Woodbridge Neighborhood Development and Cinnaire Solutions Phase I RFP Q&A

4.16.21

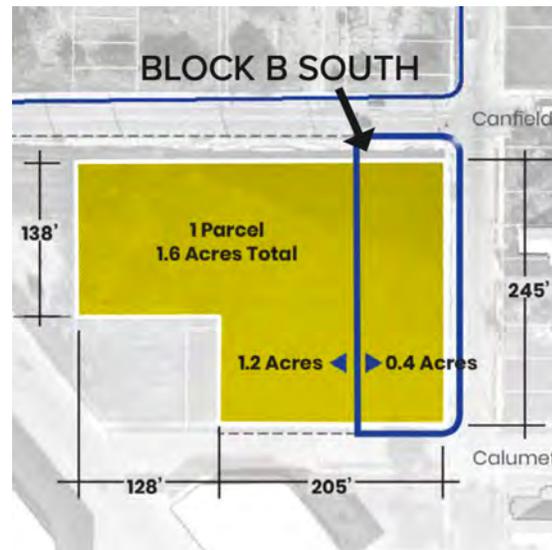
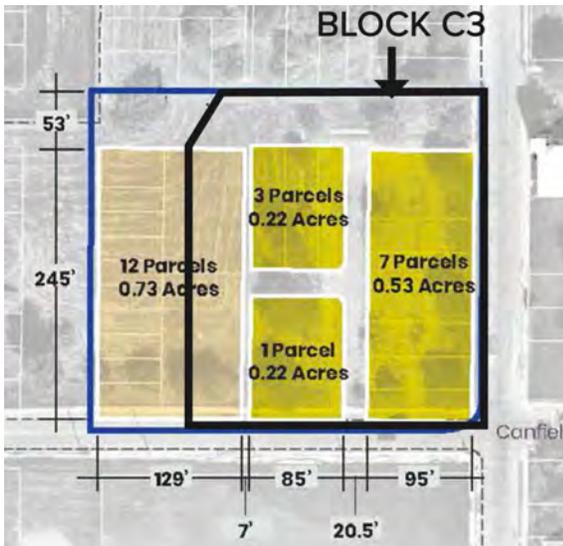
4. What are the exact boundaries of the site? Does it include the parcels in tan, or only the parcels in yellow, below? Is there flexibility in the precise site boundaries?

Yes it does include the parcels in tan, but only within the black outline. C3 has a total of approximately 66,653 square feet measuring roughly 245' x 272'. B1 South has a total of approximately 18,130 square feet measuring roughly 74' x 245'
